**Re: Riverside 2020 NDR Amendment  
For Riverside NSP 2020 Amendment**

This NDR amendment in support of the Riverside 2020 NSP Amendment.

**Genstar Development Company**  
**Riverside Neighbourhood**  
 Servicing Design Brief  
 Proposed Major Storm Water System

**FIGURE - 3.5**

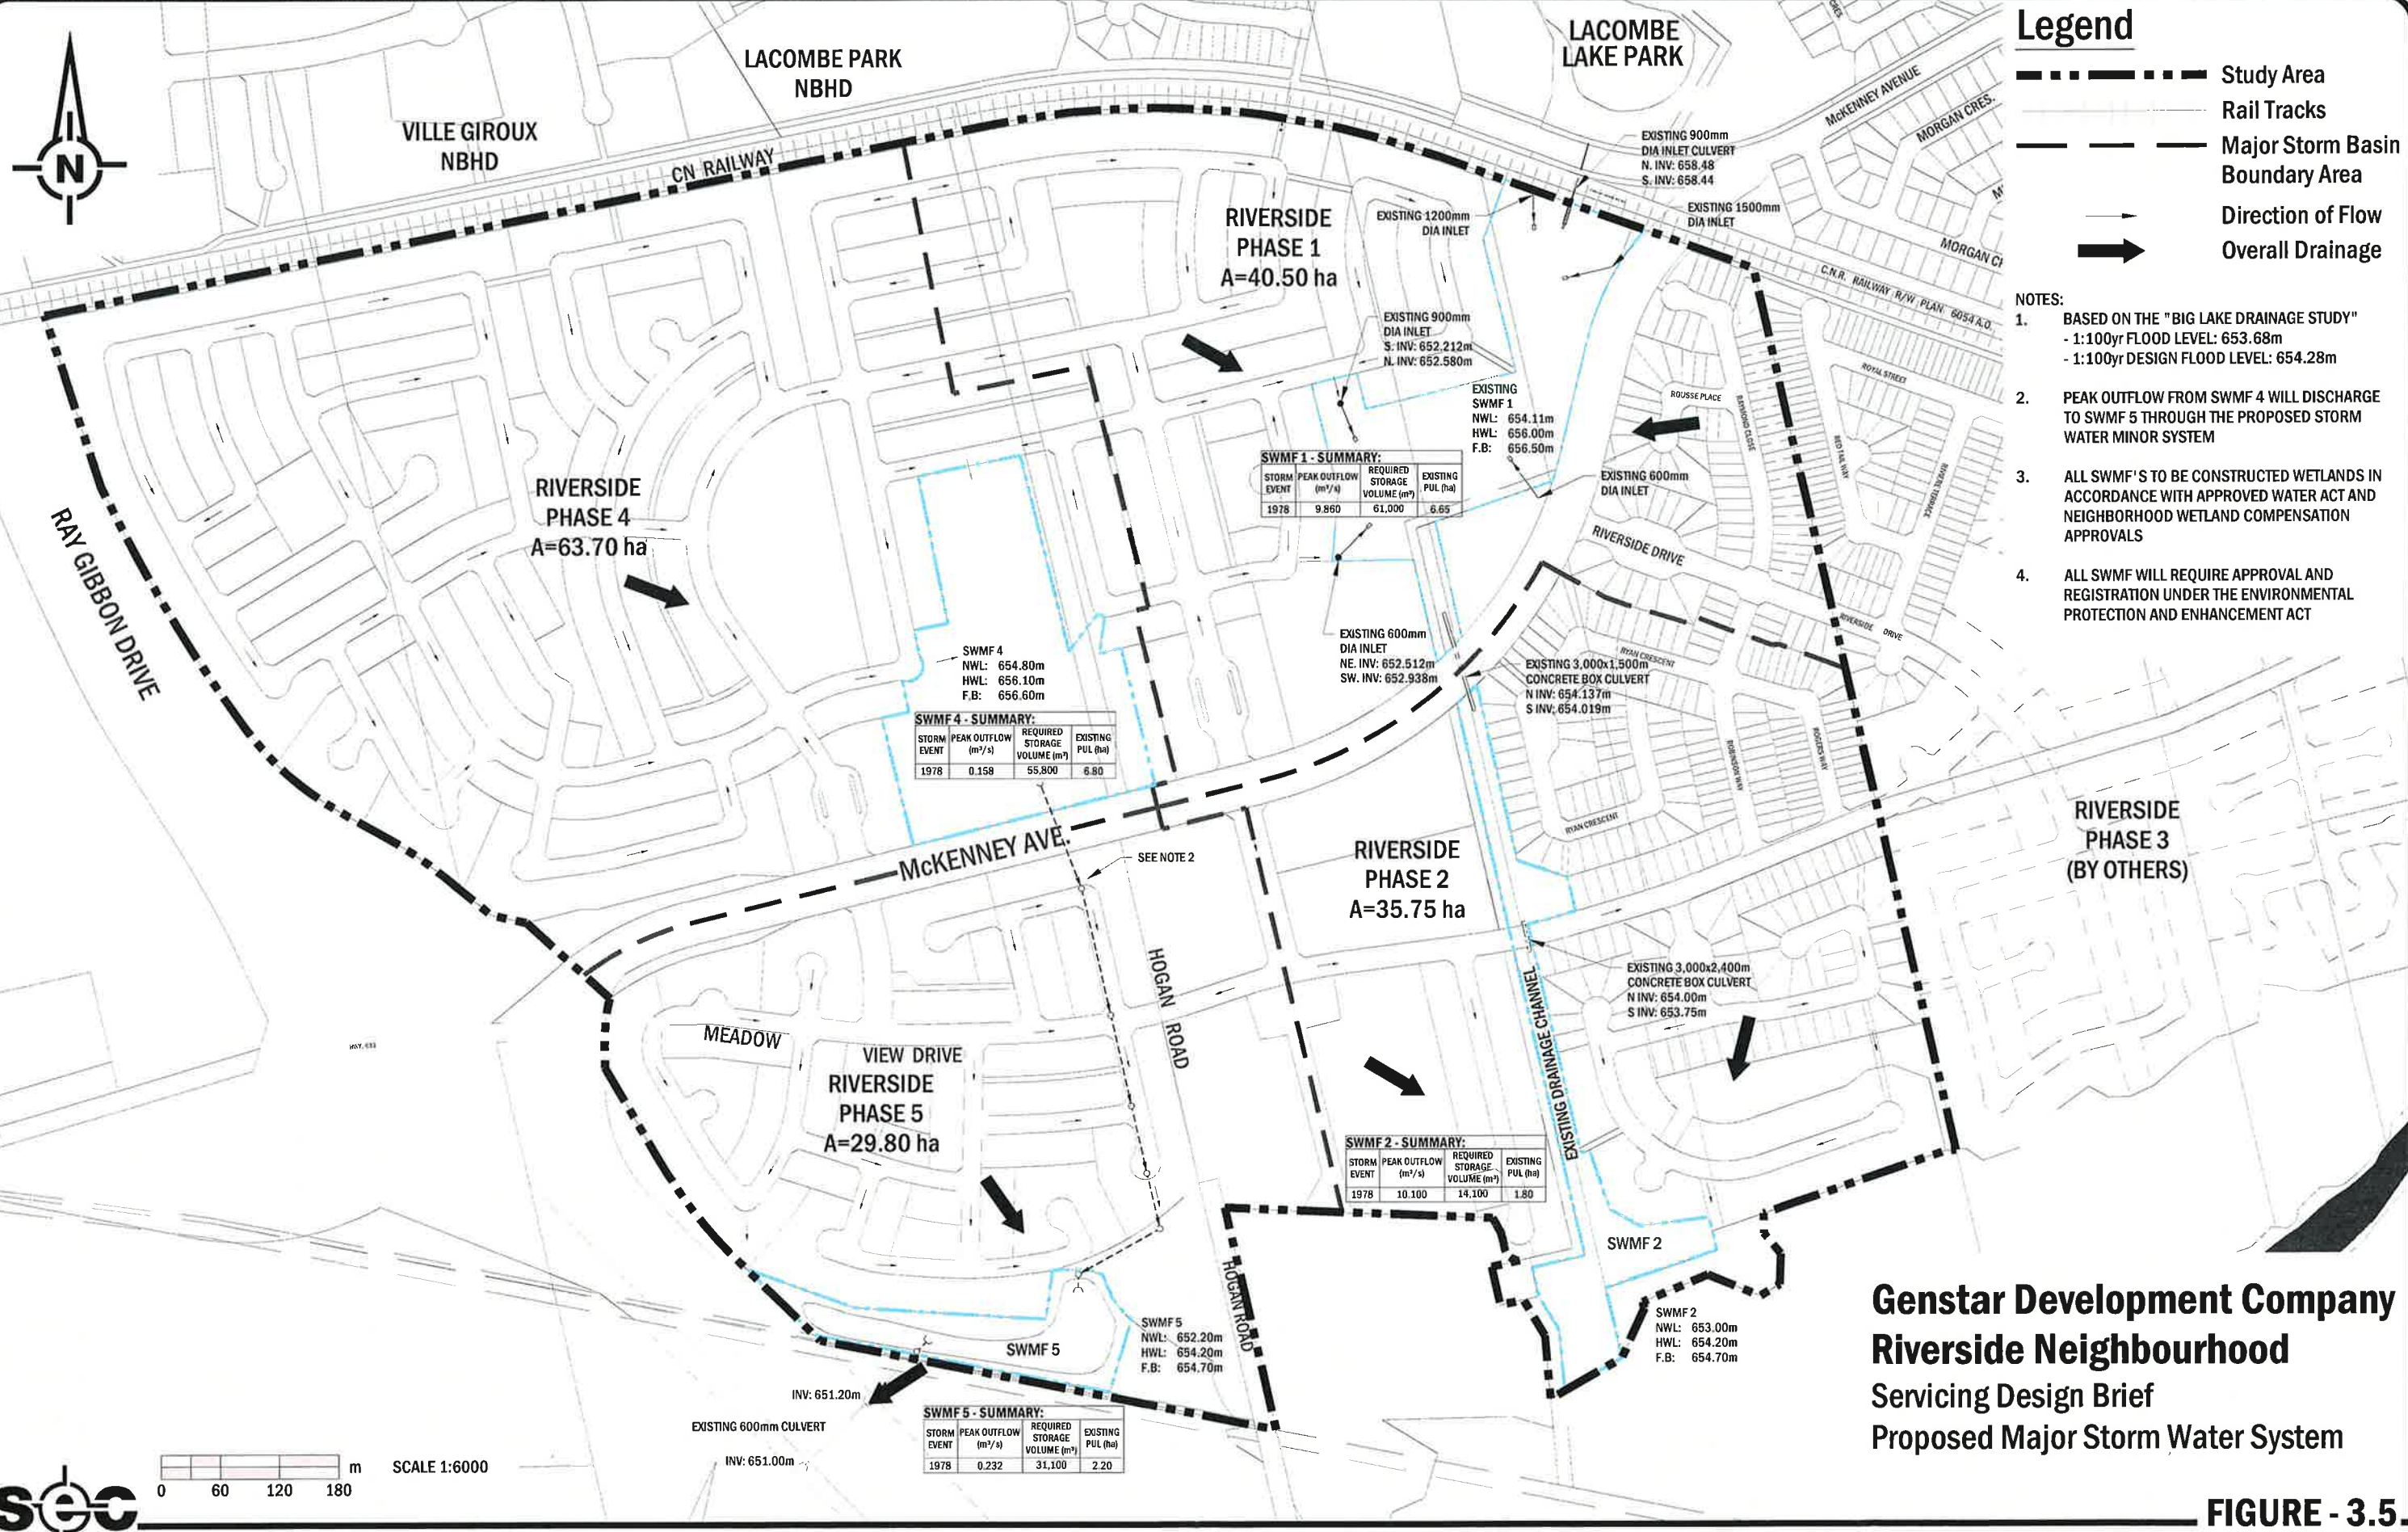
As per the existing approved NDR, SWMF 4 requires 55,800m<sup>3</sup> of storage as shown in Figure 3.5. SWMF 4 in the proposed ASP amendment, shown on Figure 3.5 R has a PUL area of 5.08 ha and provides 60,400m<sup>3</sup>. No revision is proposed to storm basin size or the runoff coefficients.
